## Service Bulletin

**Bulletin No:** JC-022-12 REV1A **Updated to include Generac Propane Units**  
(Highlighted information is new)

**Product Type:** G, H & J series ProCat and Predator-Pro

**Customer Issue:** Premature deck belt failure. (Belt failing in the initial 100 hours of use.)

This kit will include:

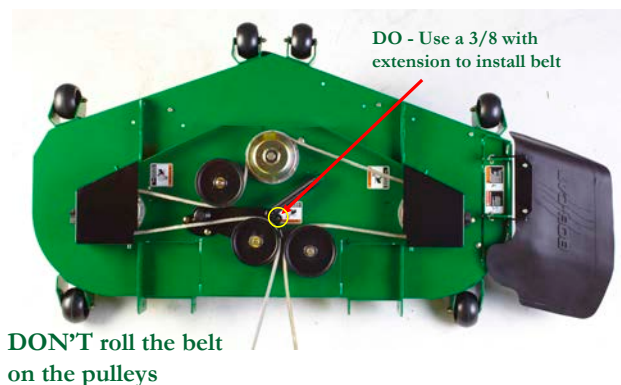
**Cause:** Idler spring tension too high, clutch engagement too abrupt.

**Action Required:** For units that experience premature belt failure, install idler belt kit **970488** for 52" units, **970497** for Generac powered 61" units or **970481** for all other 61" units. Please retain failed belt as you may be required to send it back to the factory for warranty approval.

- 1 revised idler assembly with fixed belt guide
- 1 stronger cord belt (27% higher tensile strength than original belt)
- 1 lighter tensioned spring (this is the same spring 4168493 with the yellow stripe issued earlier)
- 1 newly programmed soft start clutch module with harness (even if the unit already has a soft start clutch module on it, you will still install the new one)
- 1 new spring anchoring plate as adjusting the spring tension is critical to long belt life.
